# CITY OF ALBUQUERQUE

**RE: Main Event, Albuquerque Carpenters Training Center (File: G16-D149)**  
**4040 Pan American Freeway NE 87107**  
**Grading Plan and Drainage Plan, Engineer's Stamp Date 5-14-2015**  
**Engineer's Certification Dated 5-19-16 sheet C5 only**

Based on the Certification received 5/19/2016, the site is acceptable for a TEMPORARY 30-day Certificate of Occupancy by Hydrology.

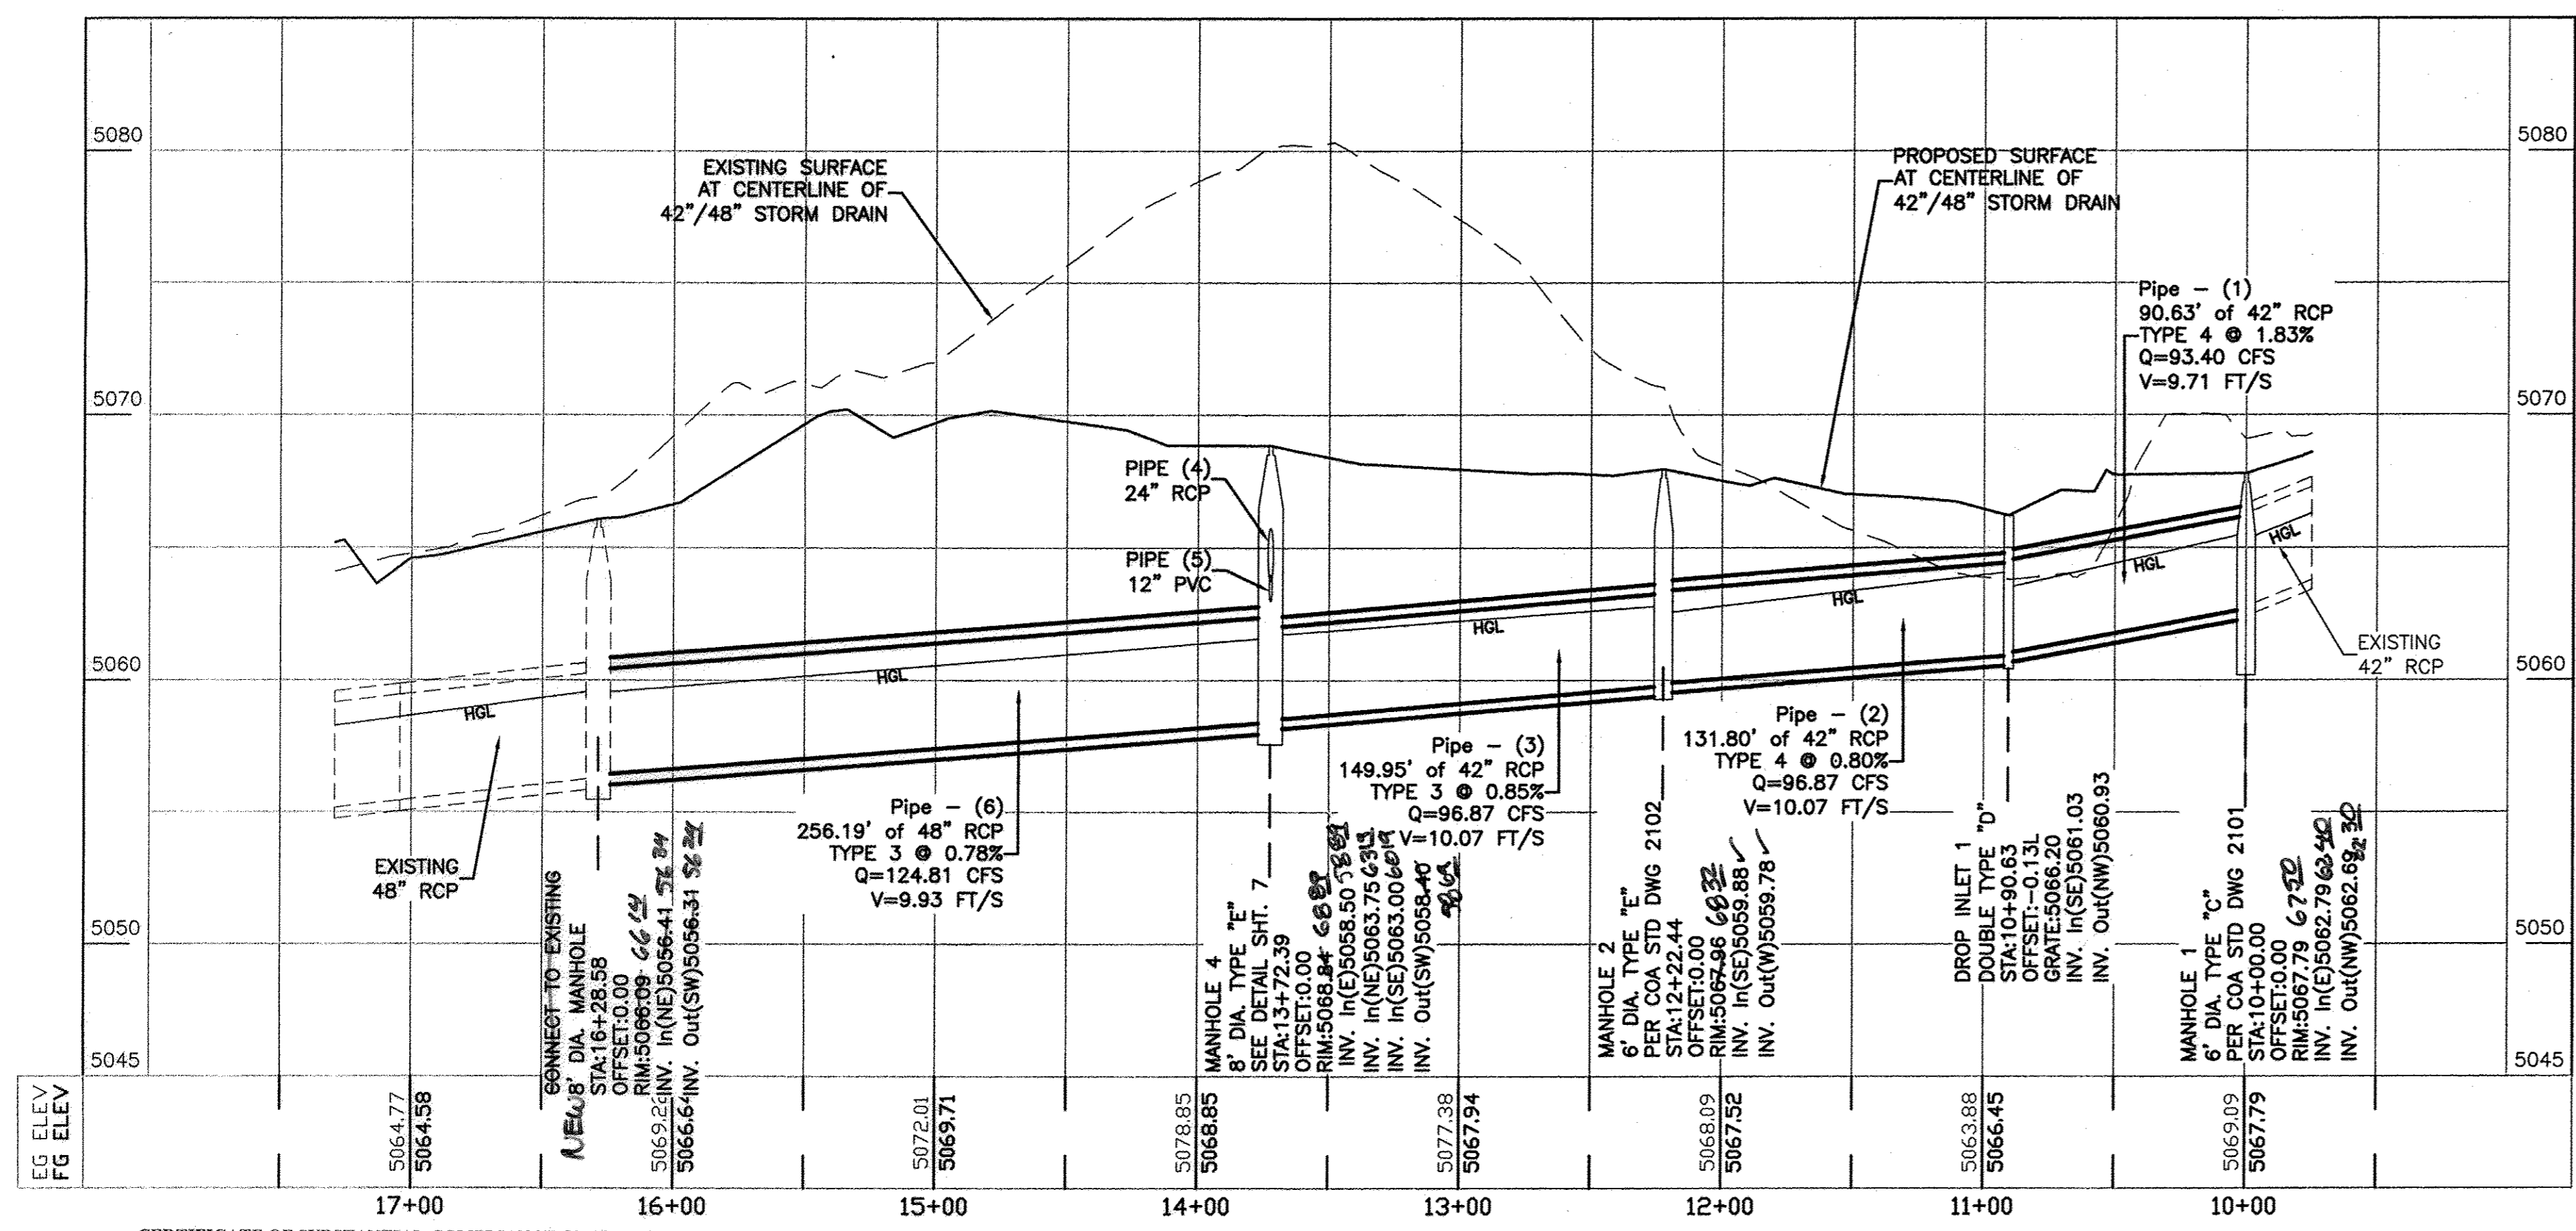
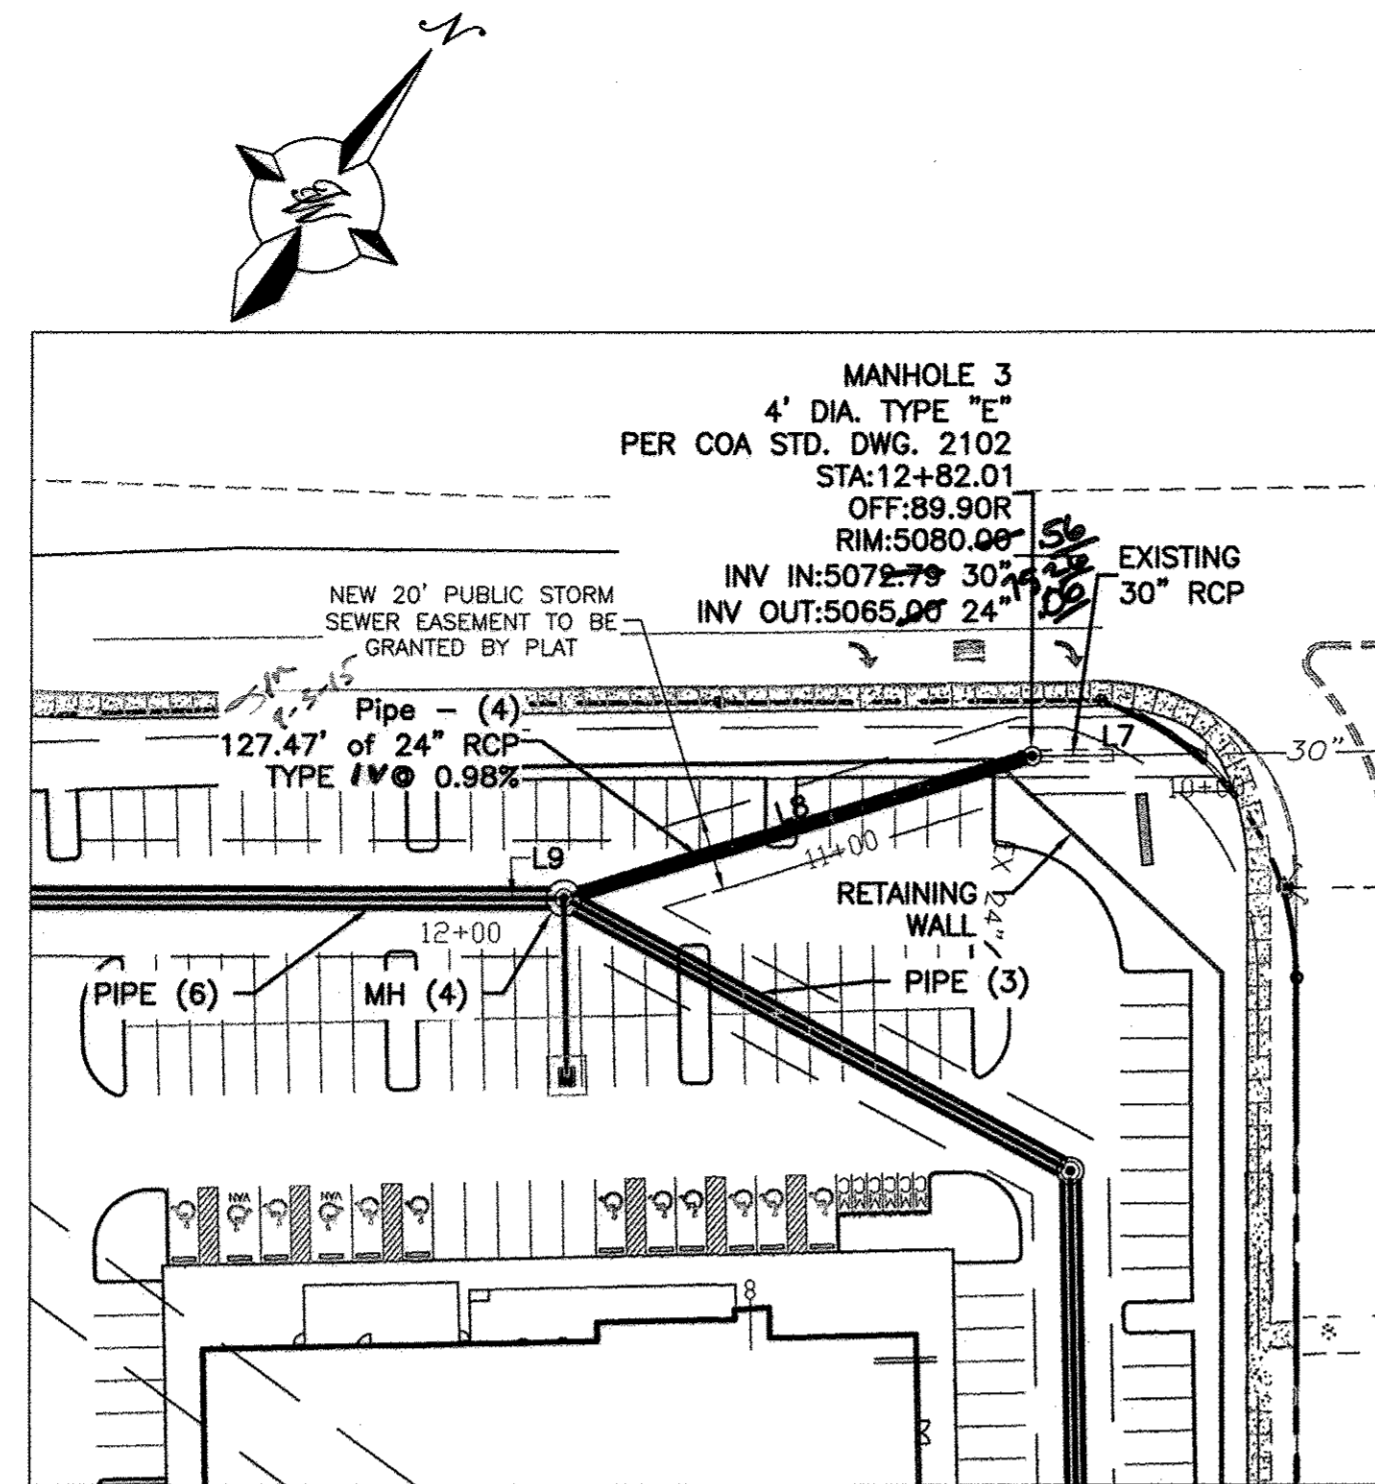
1. Drainage Plan, Sheet C6 must be Certified. All private Storm Drain improvements must be as-built and certified on this sheet.
2. Permanent ponds must be as-built and certified. Additionally, the interim sediment ponds that were to be built around the inlets on the undeveloped lot must also be certified. Curb-cuts need to be also shown on the as-built.
3. The Work-order for the Public Storm Drain has punch list items. Either the work-order must be accepted, or the punch list items completed:
  - Grout I-beam at modified double "D" inlet on Vassar Dr
  - Clip corner of concrete SD collar and remove excess concrete from SDMH at NW corner of site.
  - Grout MH barrel joints at NW corner of site.
